Well Name: TIGER	Well Location: T30N / R13W / SEC 35 / SWSW / 36.764298 / -108.180987	County or Parish/State: SAN JUAN / NM
Well Number: 17	Type of Well: OTHER	Allottee or Tribe Name:
Lease Number: NMSF078213	Unit or CA Name:	Unit or CA Number:
US Well Number: 3004530823	Well Status: Producing Gas Well	Operator: HILCORP ENERGY COMPANY

Type of Submission: Notice of Intent

Type of Action: Plug and Abandonment

General Information			
<b>Well Name</b>	Tiger #17	<b>Date:</b>	3/1/2022
<b>API:</b>	30-045-30823	<b>AFE #</b>	
<b>Field:</b>	San Juan	<b>County</b>	San Juan
<b>Status:</b>	Well is ACOI		
<b>Subject:</b>	Permanently P&A wellbore		
<b>By:</b>	M. Wissing

# PROPOSED P&A WELLBORE SCHEMATIC

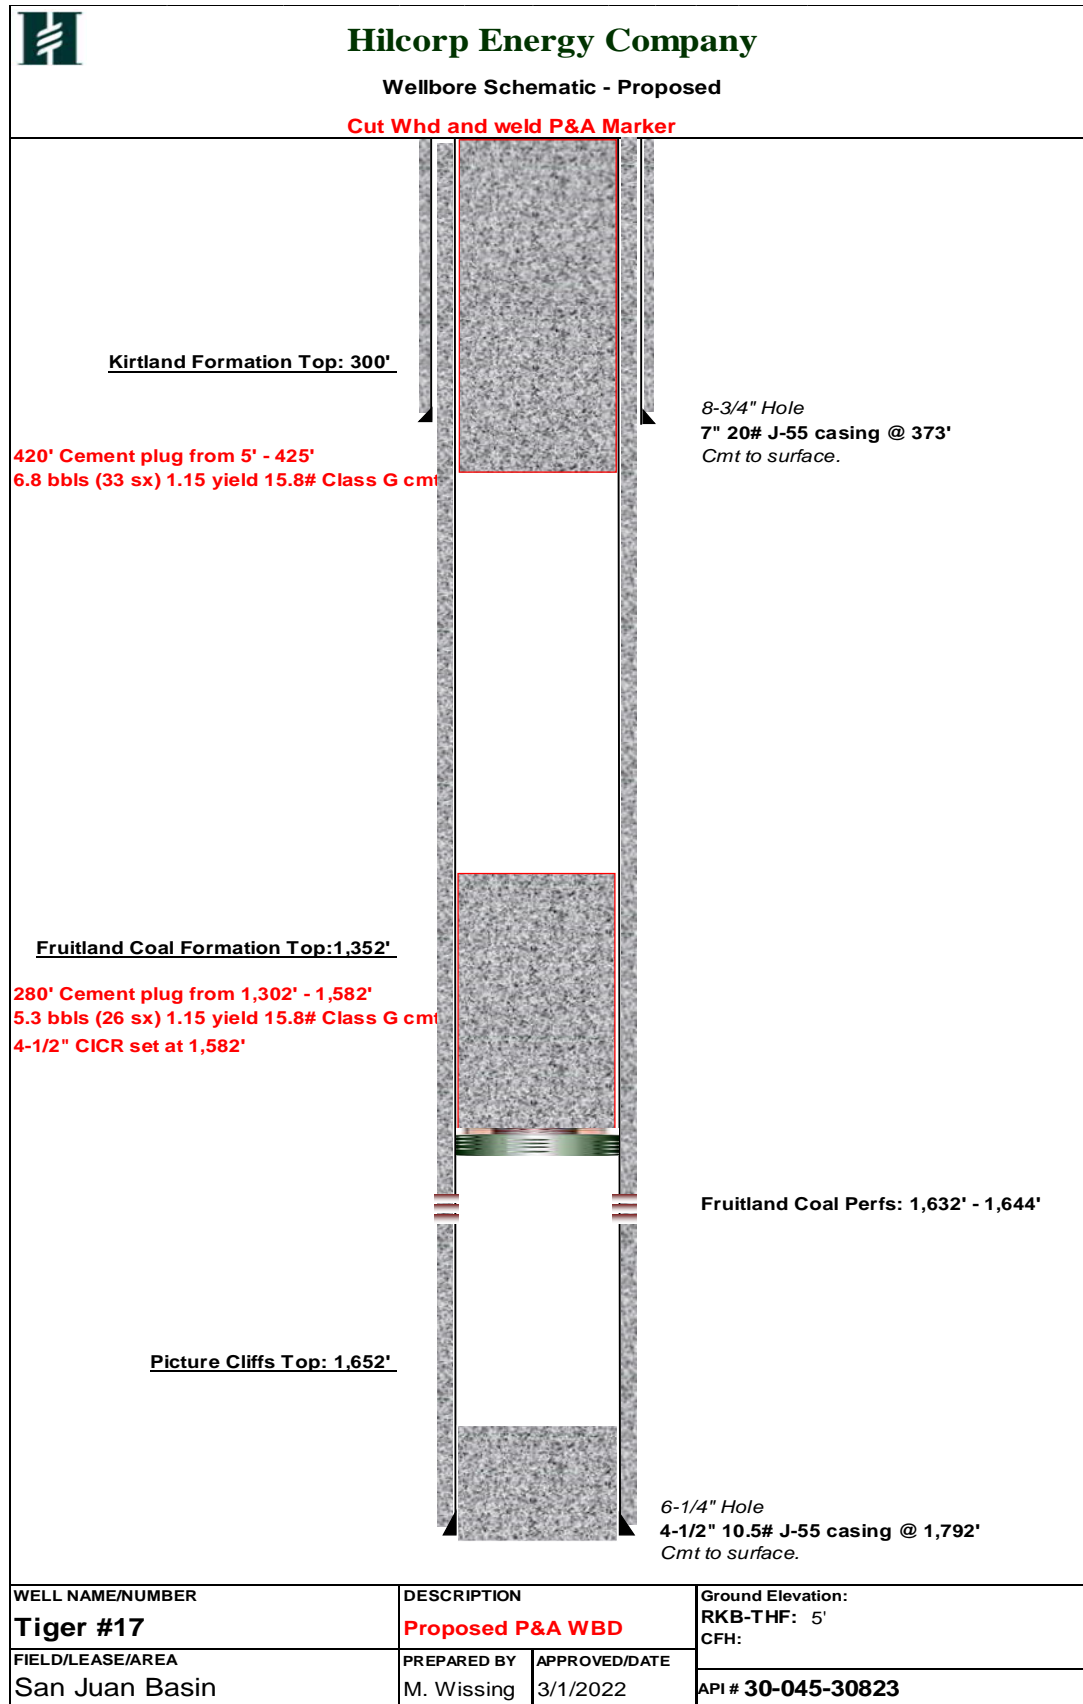
1. Plugging operations authorized are subject to the attached "General Requirements for Permanent Abandonment of Wells on Federal and Indian Lease."
2. The following modifications to your plugging program are to be made:
  - a) Pump a volume of cement below the CICR at 1582' to completely isolate the Fruitland Coal from the Pictured Cliffs.
3. Farmington Office is to be notified at least 24 hours before the plugging operations commence at (505) 564-7750.

- Pump a volume of cement below the CICR at 1582' to completely isolate the Fruitland Coal from the Pictured Cliffs.
- Fruitland Coal Perfs 1632' – 1644'.

You are also required to place cement excesses per 4.2 and 4.4 of the attached General Requirements.
